BCA/DDA Assessment Report

Grafton Base Hospital Redevelopment
Acquisition Site

Health Infrastructure

Revision 3

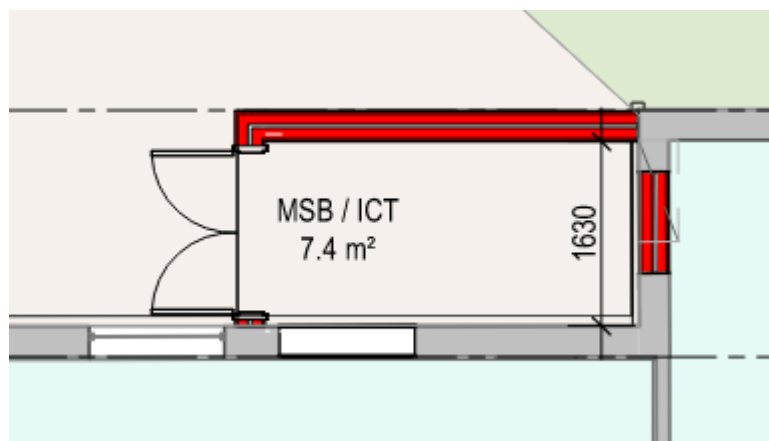
Fire engineer to demonstrate that any roofs between separate buildings do not connect separate buildings / fire compartments.

Level 1

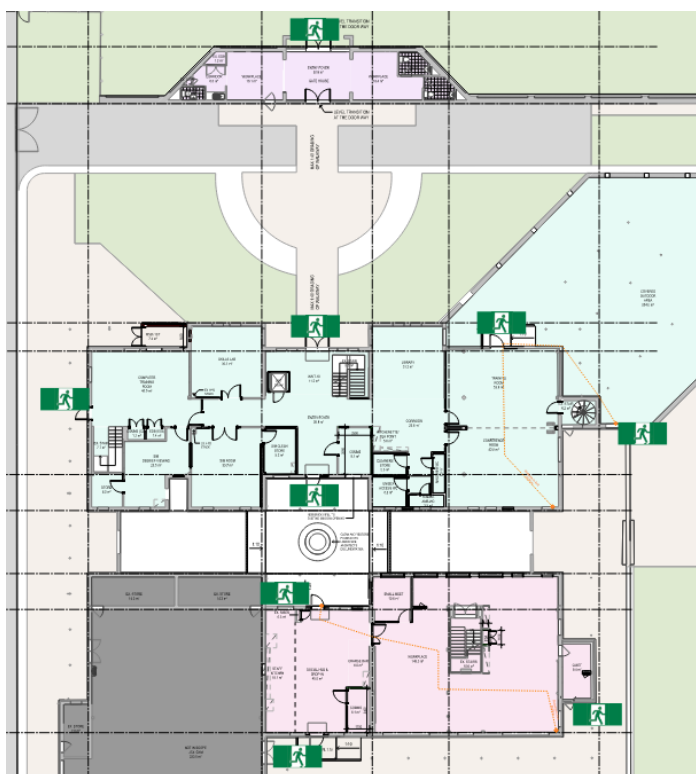
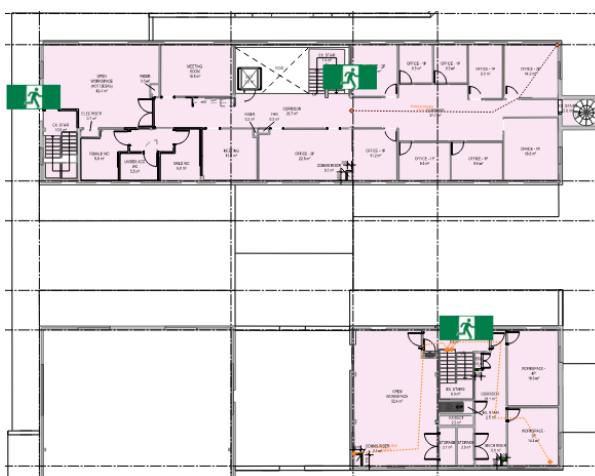
Note existing circular stair does not comply for egress as <1m wide. It is therefore not required to be considered a required exit for the scoped works.

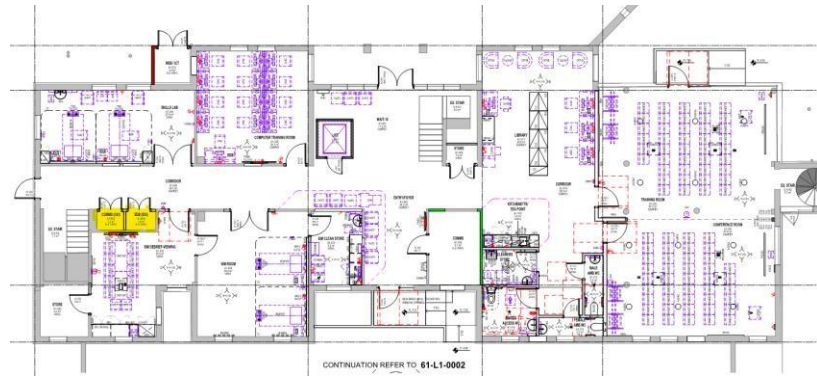
Comment: Confirmation is required that once exited the building persons can reach public road without passing back under parts of the buildings or another structure.

The egress strategy to public road requires persons to pass back under roofs, gangways / through adjacent building in order to reach public road this shall be addressed by way of fire engineered strategy. All roofed areas shall be confirmed on plan for FER consideration noting this is also an compliance issue for connection of buildings - see Part C.

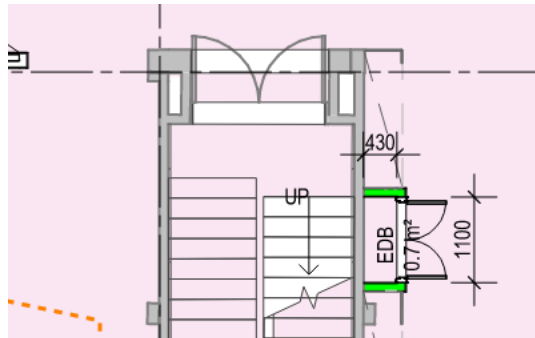
Storage under stairs appears to be at the level 1 workplace room.

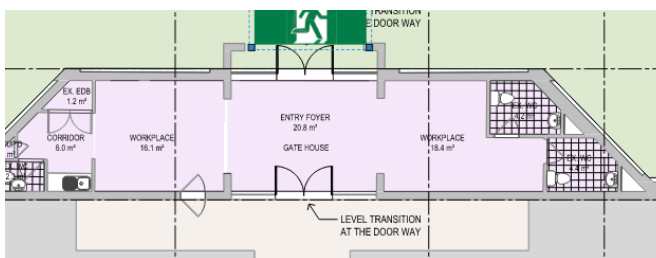
The gatehouse entry door to be upgraded for DDA compliance. The door is also serving as an egress path for Black A and B therefore is to swing outwards (direction of egress). Ensure at least one leaf is min 920mm for DDA compliance. The plan now shows this area complies.

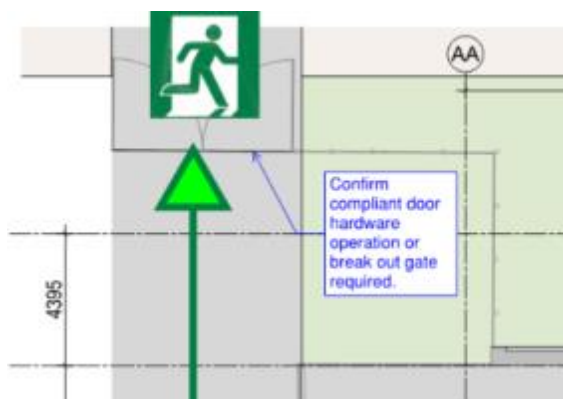
Large gates serving as security/ vehicle entry point have potential to not comply for latch type and door/ gate force. Confirmation is required in this regard or break out swing exit required.

Figure 1

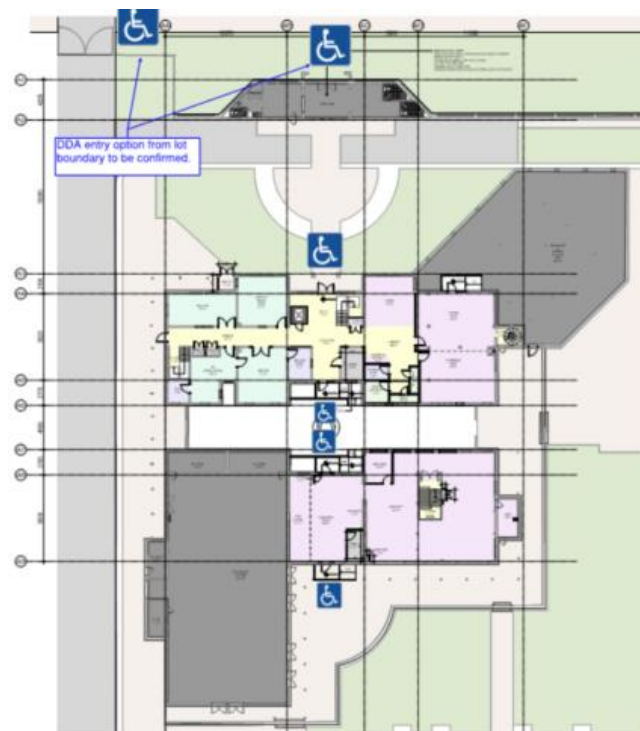
Confirmation is required on designated accessible entry points. The following is considered to be the accessible pedestrian entry point; Note site plan suggest two option, final option including accessible path of travel to be confirmed.

A compliant accessway from lot boundary and any accessible car parking (where parking is provided) shall be confirmed. It is noted no parking proposed in current design therefore n/a at this stage. To be monitored as the design progresses.

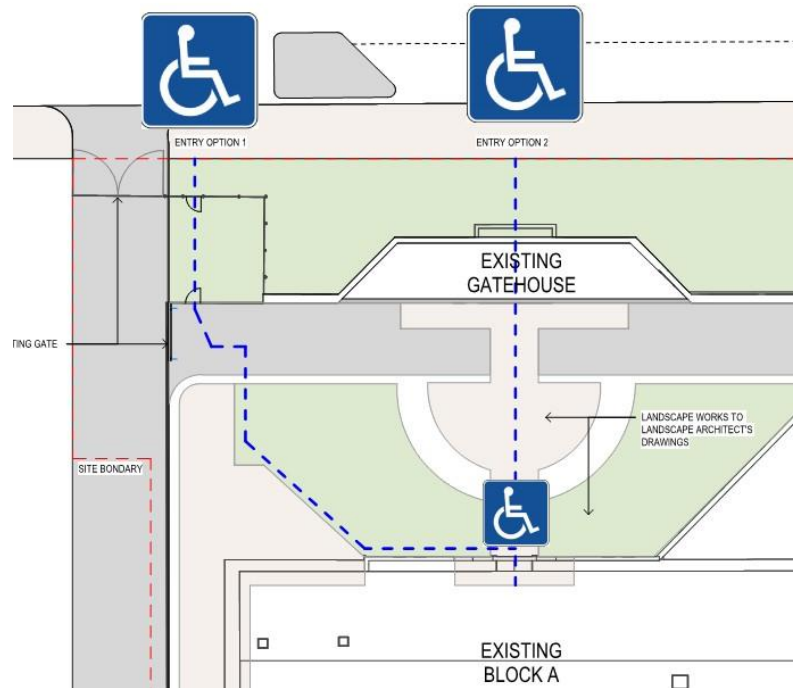
Access via the lot boundary is to be confirmed. Current plans depict grass only in front of entry/foyer. Plans required to demonstrate an accessway to the entry point of both buildings.

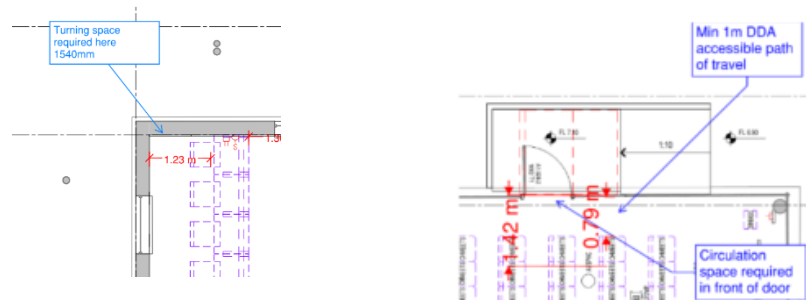
D4D3 (1) – Location of spoon drains in accessible path of between accessible buildings and allotment boundary do not comply with abutment of surfaces requirements of AS1428.1. A ramp infill is required to be provided over the top and be subject to assessment within performance solution.

D4D4 (f) – A performance solution is proposed to omit access to upper storey on Block B on basis upper storey is Class 5 and under 200m² however lower floor has Class 9b part by way of connected out of scope hall being Class 9b which does not comply with the requirements of this Clause.

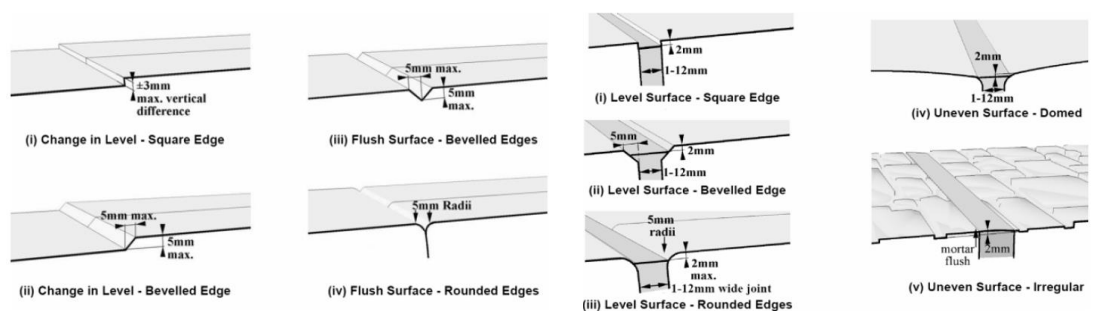
Comment: Numerous area where turn space was not achieved. Rectification is required in some areas, others to be addressed by way of Performance solution. Typical below see marked plan for further information.

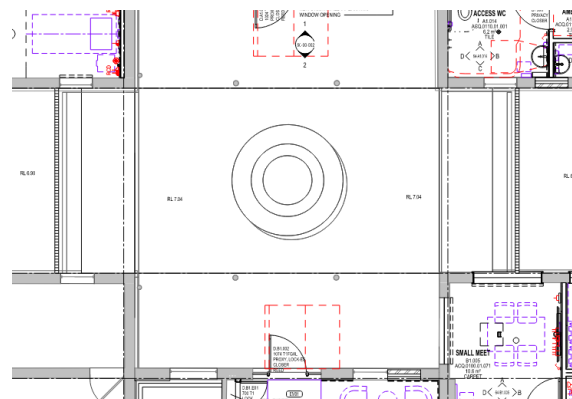
Comment: It is understood an updated step ramp proposal is suggested to mitigate these issues. Confirmation to be confirmed on plan.
